From: [REDACTED]
Sent: 12 January 2026 11:45
To: Anna Tidey
Subject: Fwd: Planning application DM/25/2859 - 104 Middle Village, Haywards Heath
Attachments: Win Widget weather bar.pdf

**Subject: Planning application DM/25/2859 - 104 Middle Village,
Haywards Heath**

I refer to your planning application for 'Replacement of 3 timber windows with 3 uPVC windows of the same look and colour', for which I am the Case Officer.

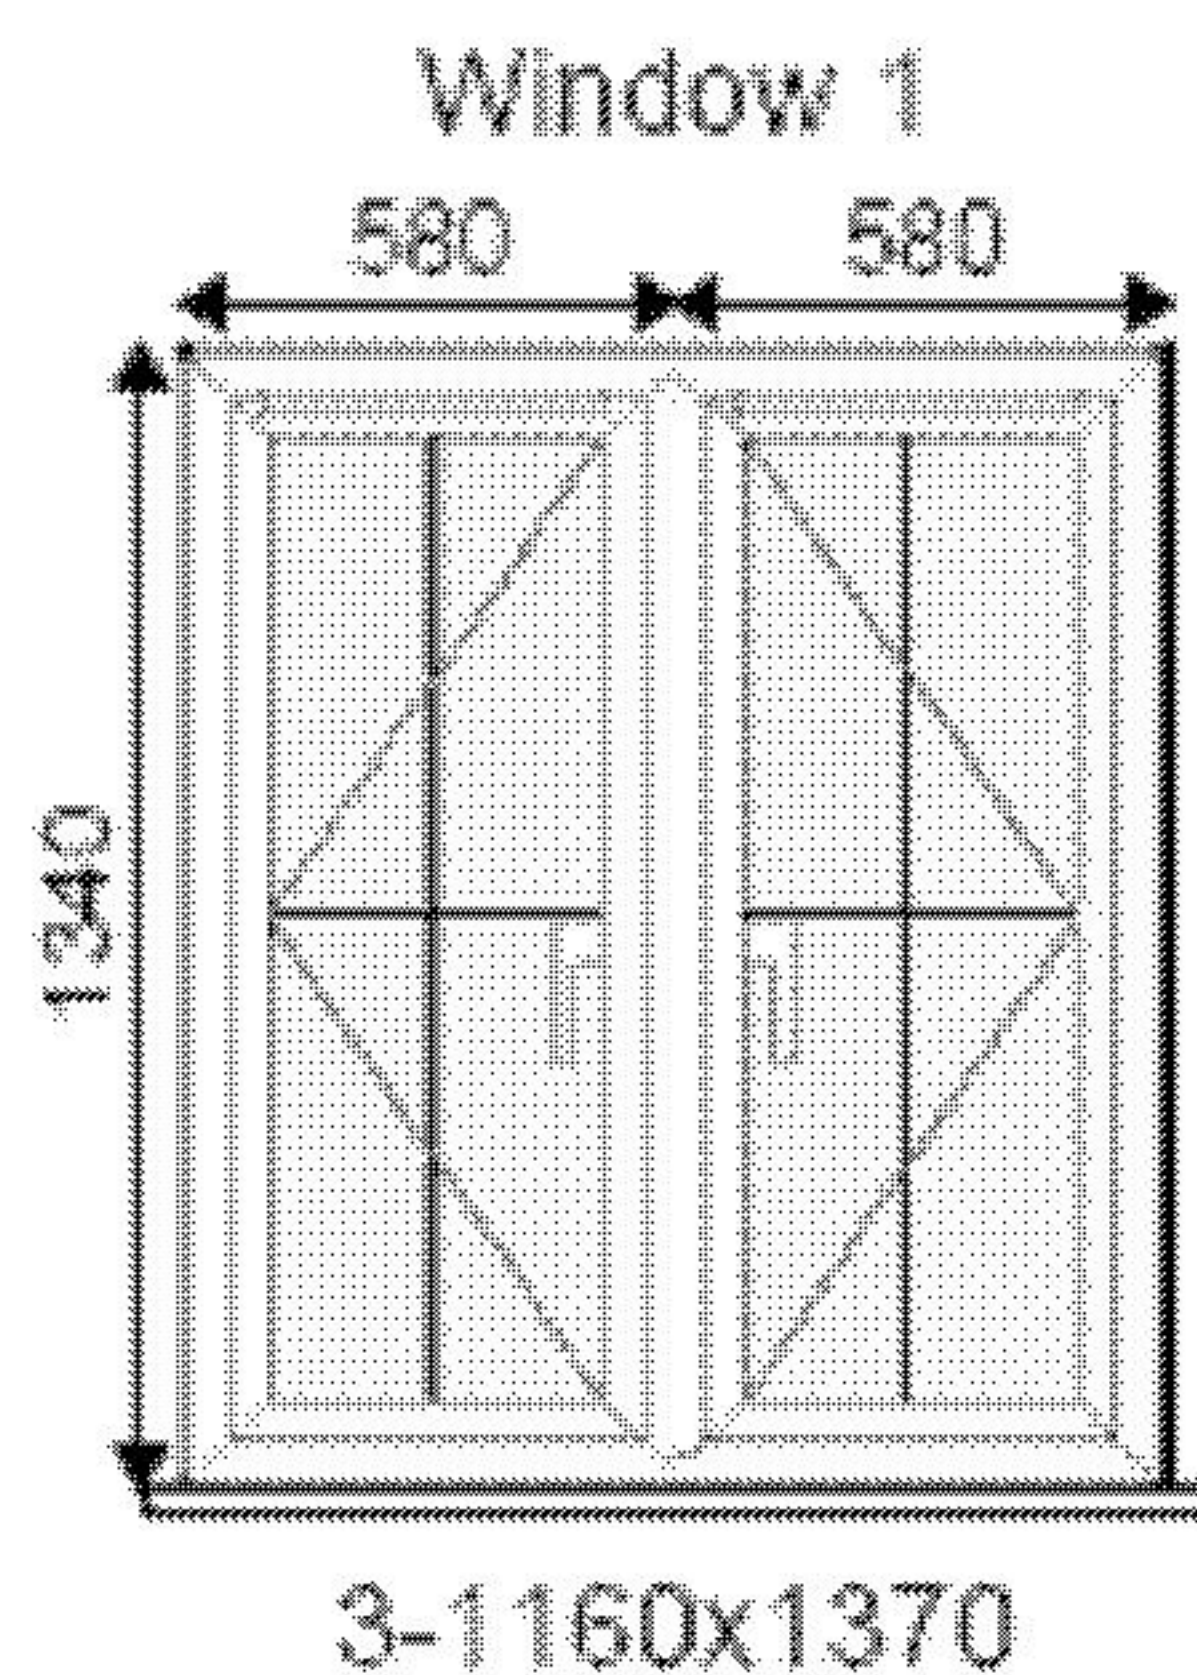
I was on site at your property yesterday to view the current windows, and the others in your block. I note that the existing windows are all of a similar style in the block and the elevation on which your three windows are located is publicly visible in the street and from the car parking area below. The current windows have a projection on the lower pane, above the window sill (see below photo of a ground floor window in your block).

I have reviewed the proposed window plans that have been submitted with your application, extract below:

The submitted illustration for DM/25/2859 does not clearly show this projection on your proposed windows. Please can you assure me that the design of the replacement windows will exactly match the external appearance of the existing windows to maintain a consistent appearance on the block? Your supplier may be able to provide cross sections or more detailed design drawings to support the proposal?

Please find attached details of the bar which would be fixed at the bottom of the window .

The photo of the window shows an overhang on the bottom bead as timber windows occasionally require this. The uPVC window does not need this as it weathers differently, however, I can fit a drip bar in this position purely for aesthetic requirements.
